UNITED STATES PATENT AND TRADEMARK OFFICE

APPLICATION NO.	FILING DATE	FIRST NAMED INVENTOR	ATTORNEY DOCKET NO.	CONFIRMATION NO.
10/772,736	02/05/2004	Juan-Jann Jou	24061.80 (TSMC2003-0343)	5636
42717	7590	09/20/2006	EXAMINER	
HAYNES AND BOONE, LLP 901 MAIN STREET, SUITE 3100 DALLAS, TX 75202			NGUYEN, THANH T	
			ART UNIT	PAPER NUMBER
			2813

DETAILED ACTION

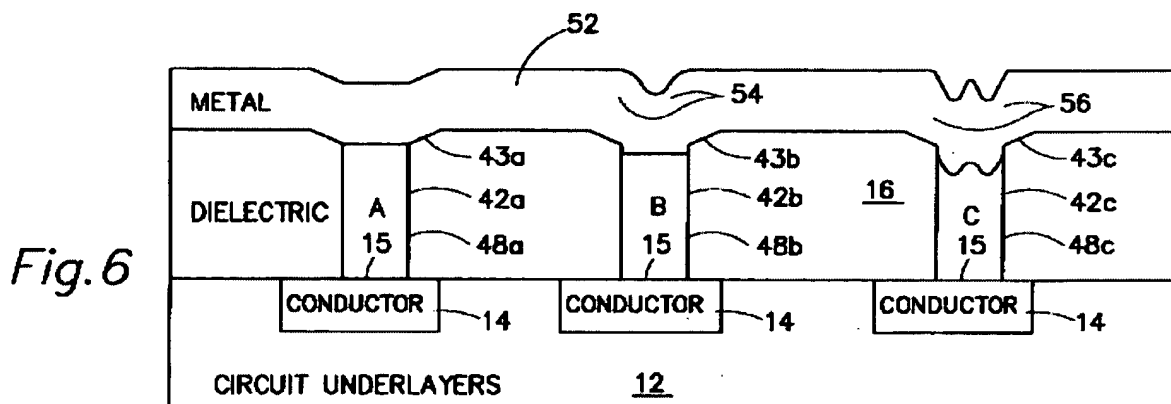
Claims 27, 33, 36, 40-41, 47, 49 are rejected under 35 U.S.C. 102(b) as being anticipated by Straight et al. (U.S. Patent No. 5,567,650).

Referring to figures 3-6, Straight et al. teach an interconnect structure, comprising:

a first conductive layer (48c) located in a substrate (12/14, and the bottom part of layer 16);

a dielectric layer (the top part of layer 16) overlying the first conductive layer (48c) and having an opening (40c) extending to the first conductive layer (48c); and

a second conductive layer (52) located in the opening (40c) and contacting a portion of the first conductive layer (48c), wherein an interface between the first and second conductive layers substantially conforms to a substantially curvilinear profile (see figure 6 for detail).

Regarding to claims 33, 47, wherein the interface profile is substantially W-shaped (see figure 6).

Regarding to claims 36, 49, wherein the interface profile is substantially concave relative to the substrate (see figure 6).

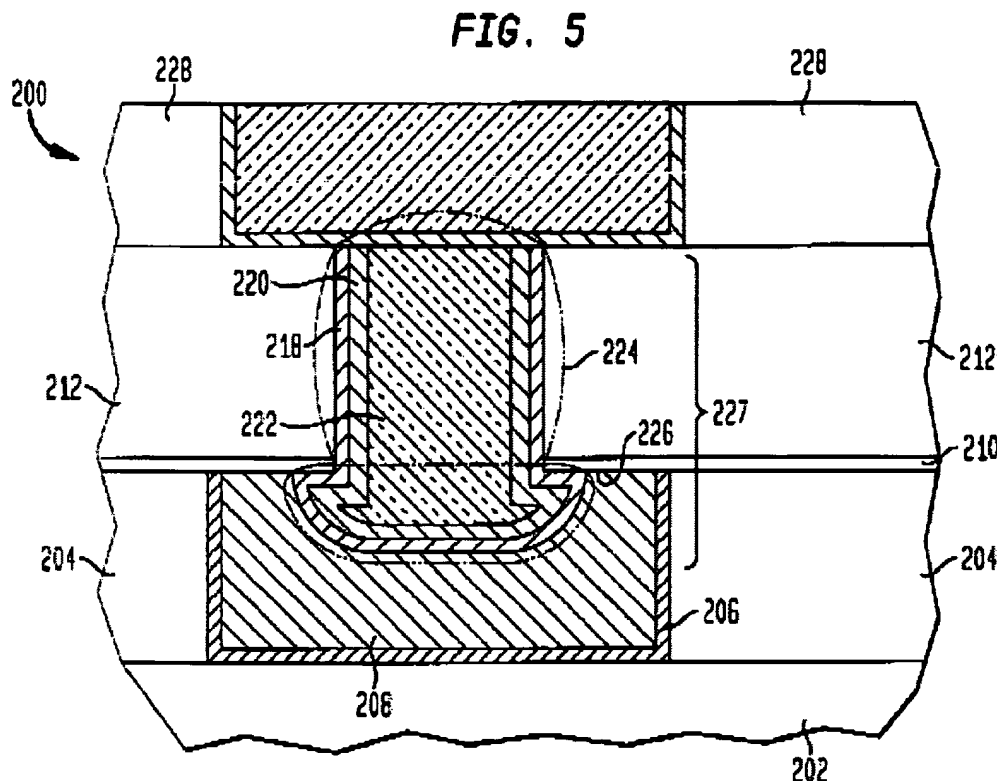
Claims 27, 31-32, 36, 39-41, 45, 46, 49 are rejected under 35 U.S.C. 102(e) as being anticipated by Barth et al. (U.S. Patent No. 6,613,664).

Referring to figures 4-5, 8, Barth et al. teach an interconnect structure, comprising:

a first conductive layer (208) located in a substrate (202/204);

a dielectric layer (210/212) overlying the first conductive layer (208) and having an opening (213) extending to the first conductive layer (208); and

a second conductive layer (218/220/222) located in the opening (213) and contacting a portion of the first conductive layer (208), wherein an interface between the first and second

conductive layers substantially conforms to a substantially curvilinear profile (see figure 5 for detail).

Regarding to claim 31, 45, diffusion barrier layer (218) interposing the dielectric layer and the second conductive layer (see figure 5).

Regarding to claim 32, 46, diffusion barrier layer (218) interposing the first and second conductive layer and substantially conforming to the interface profile (see figure 5).

Regarding to claims 36, 49, wherein the interface profile is substantially concave relative to the substrate (see figure 5).
